# Revised SKYES Departure

**SKYES-ONE DEPARTURE (SKYES 1 • SKYES)**

MARCH AFB (00RV)

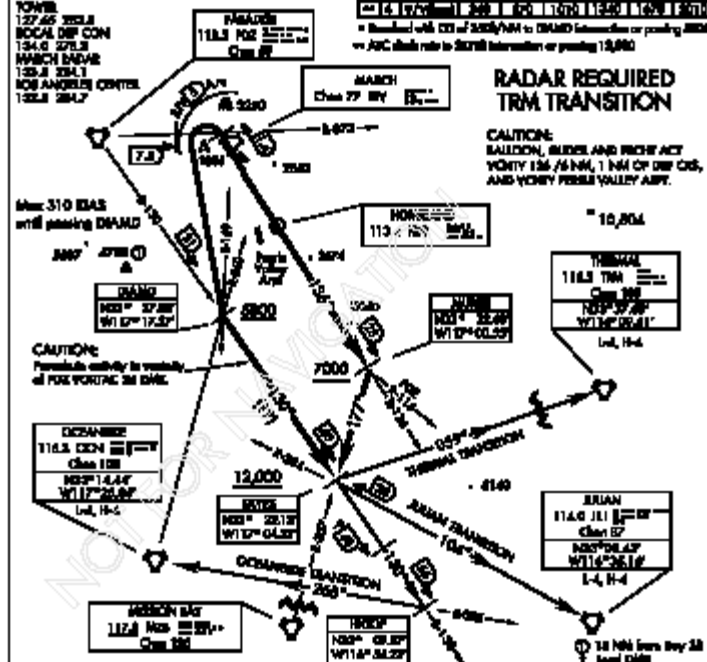
# Differences Rwy 32

- Lengthened the straight portion to PDZ R-073 from PDZ R-075
- Changed turn 155 heading to direct PDZ R-130/21 DIAMD intersection (turn to fix)
- Changed climb rate to 250 FPM from 280 FPM
- Deleted 4000 ft hold down altitude
- Added ATC climb rate to SKYES 310 FPM

# Differences Rwy 14

- Lengthened straight segment from 20 miles out to 25 miles to MURRE intersection
- Replaced 162 heading, uses MZB R-357 Mission Bay Vortac (turn to fix SKYES)
- Added ATC climb rate to SKYES 340 FPM

- Change to FAA criteria
- FAA 8260-3B requires positive course guidance (PCG) for all segments except initial straight segment. Rwy 32/ Rwy 14 had to be redeveloped to remove the turns of 155 degrees and 162 degrees to incorporate positive course guidance.
- PCG requires guidance from or to a NAVAID or direct to a fix
